Project Name: Klinefelter - SFD
Project Location: 8469 East Spring Park
 Eden, UT

The following residential plan review comments address non-compliance with governing 2015 IRC, as adopted by the State of Utah and potential errors or omissions in the proposed design.

PLAN REVIEW COMMENTS:

S3. S2.1:

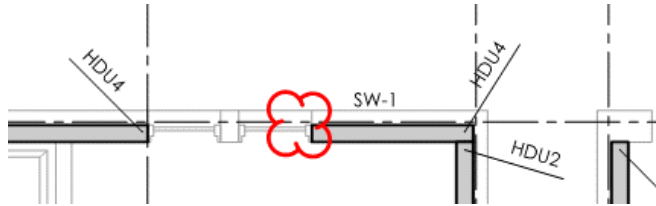
- C. The jogs of the building disrupt the continuity of the top plate chords. Please verify that the chord or sub chord extends far enough into the adjacent diaphragm to develop the axial force through shear transfer. This may require additional blocking and strapping. Diaphragm sheathing to resist direct tension or compression forces is not permitted. (ASCE 7-10 1.4, 12.1.3, 12.1.4, 12.10 and 12.11.2.2.)

Each wing or section of the house has been designed as independent building with its own diaphragms, shear walls, chords, etc. Wind significantly governed over the increased seismic forces including 20% of the roof snow load and increases for irregularities. Each section or wing is designed for the full effects of the wind as if each section were fully exposed. The design is conservative. The top plates for each section are continuous, and the chords are adequate. Each diaphragm is small, and lateral loads are transferred through an abundance of shear walls that then transfer the loads into the concrete foundations.

S4. S3.1:

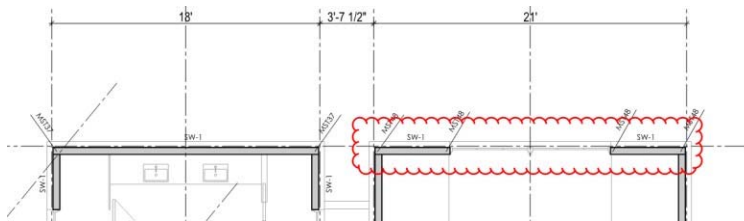
- D. Shear wall schedule shows SW-2 has 4" edge nailing. It shows SW-3 has 3" edge nailing. The sill bolt appears to be smaller at the higher capacity shear walls. Please verify if the anchor bolt should be larger. (IBC 1609, 1613)

SW-2	7/16" APA	8d	4" O.C.	12" O.C.	5/8" x 12" @ 12" O.C.
SW-3	7/16" APA	8d	3" O.C.	12" O.C.	1/2" x 10" LONG @ 24" O.C.

The anchor bolts have been revised to 5/8" dia. X 12" @ 16" o.c. See updated plans.

S6. S4.1:

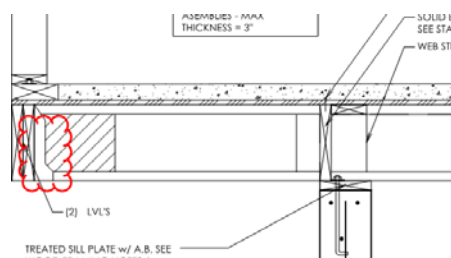
- A. Detail 10: Please verify if hanger is upside down for the cantilever application. (IBC 1604)

The connection is correct. This is not a cantilever. The double rim is supported by the steel beams.

- B. Detail 4, 5, 8, 9:

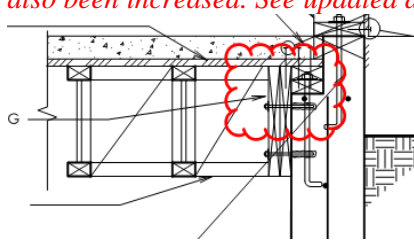
- I. Anchor bolts are shown epoxied into the concrete foundation wall. Information for type, embed depth, spacing, brand of epoxy, edge distance...etc are not obvious on the drawing. Please verify and provide. (IBC 107)

- II. The edge distance appear to be very close to the edge. This may be ineffective. Please verify and provide adequate edge distance. (IBC 1604)

The anchor bolts are intended to be cast-in place, with an option to drill and epoxy them if desired. There are notes for post installed anchor bolts on sheet S02. More information and options have been added to the plans. See additional calculations and updated drawings.

The edge distance for the lower sill plate has been calculated at 2". See additional calculations. Although not taken into account in the calculations, the ledger will also help confine the connection. An option has been added to use Simpson SB or SSTB anchors to make the bolt placement easier. The length of the anchor bolts for the top sill plate has also been increased. See updated details and additional calculations.

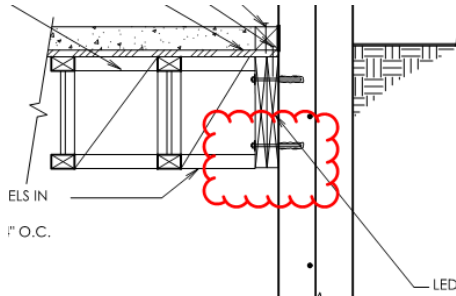
- C. Detail 7, 8, 9, 6: The ledger framing appears to experience cross grain bending. This is not permitted. Please consider providing tension device to the concrete foundation wall. (ASCE 7 12.11.2.2.3)

Straps have been added to eliminate the potential cross grain bending in the ledgers. See updated drawings.

S7. S5.1:

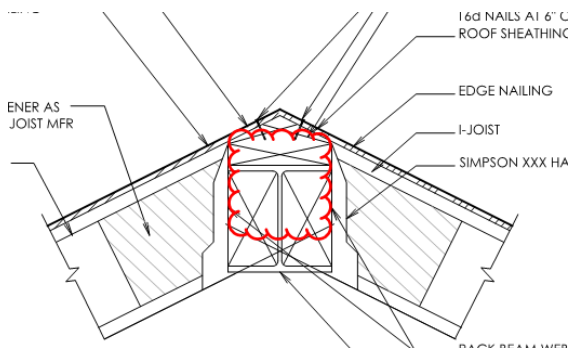
- A. Detail 2: Please clarify wood connection to steel beam. It is unclear from the detail how they are connected. (IBC 1604)

See updated details with additional information.

- B. Detail 4:

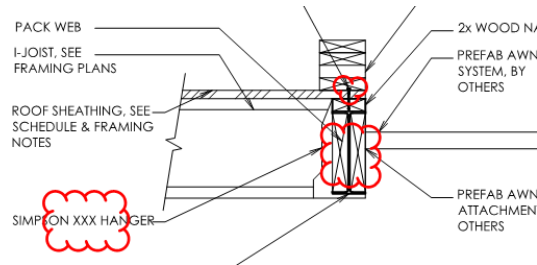
- I. Simpson hanger has not been identified. Please verify and provide hanger information for all details. (IBC 107)
See framing notes, and updated details. STD hangers are adequate.
- II. Please clarify connection of wood to steel beam. Connection information is not obvious on the plans. (IBC 107)

See updated details.
